Application: 253071

Biodiversity Net Gain / Landscaping Screening

Section 1

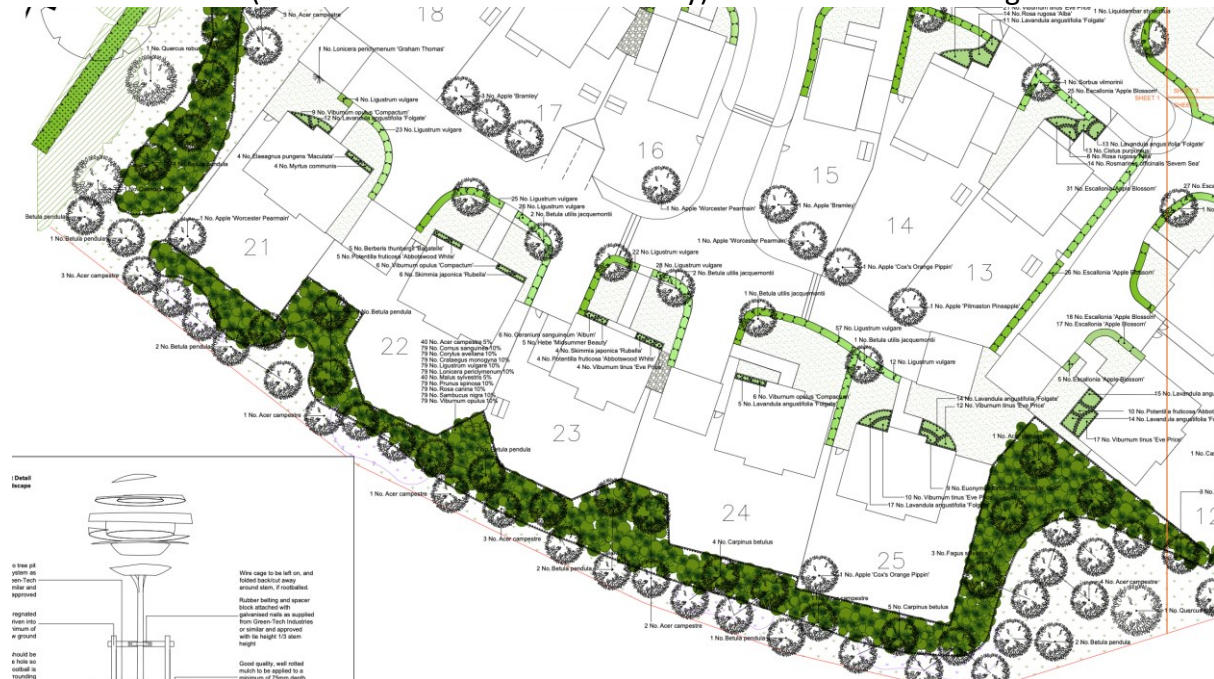
Each CLW boundary house should have the following behind their fences:

Rear Garden in the image above, refers to the rear gardens of Canberra Lake Way Properties 6-12 and 22-26.

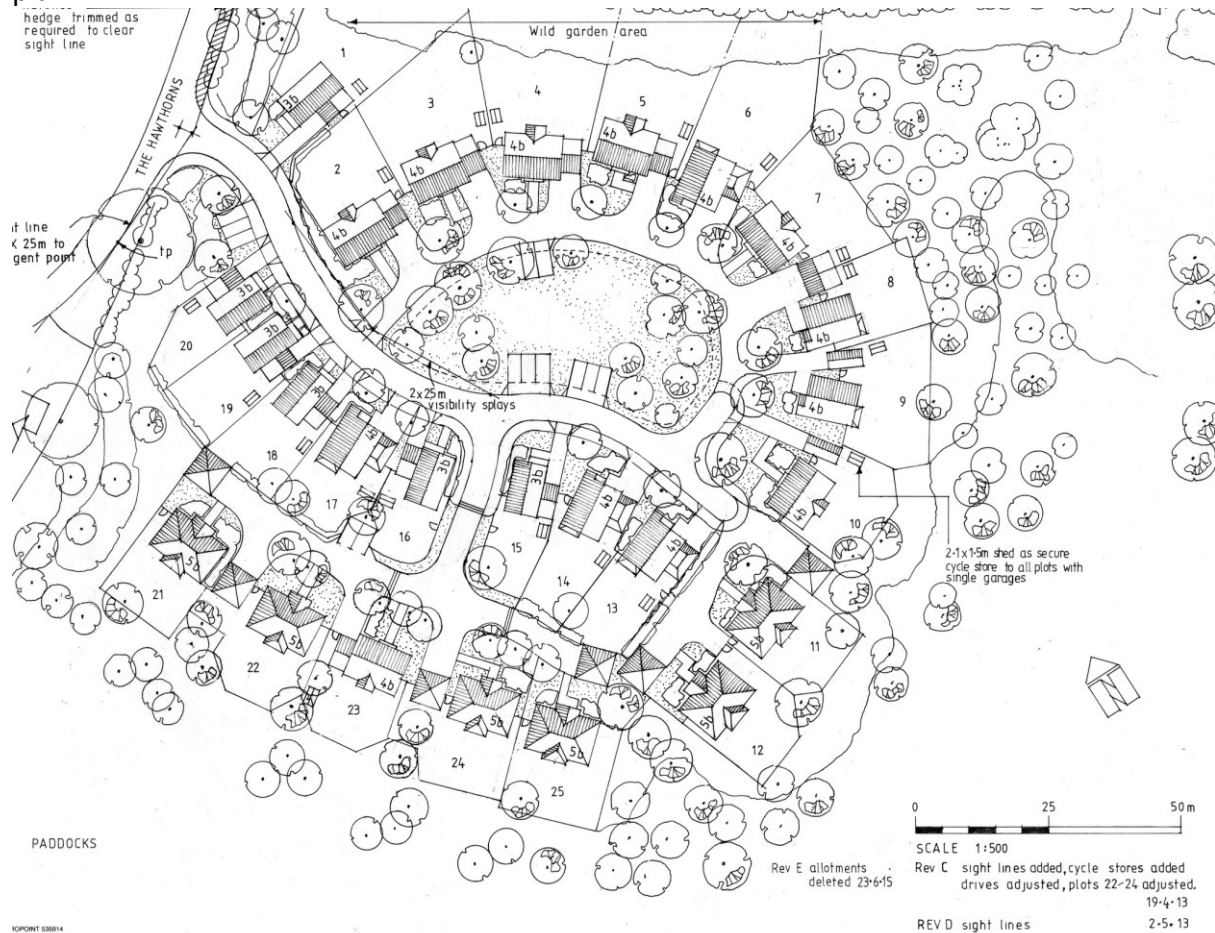
Behind Plot 21-25 (now No 22-26 Canberra Lake Way) should be the following:
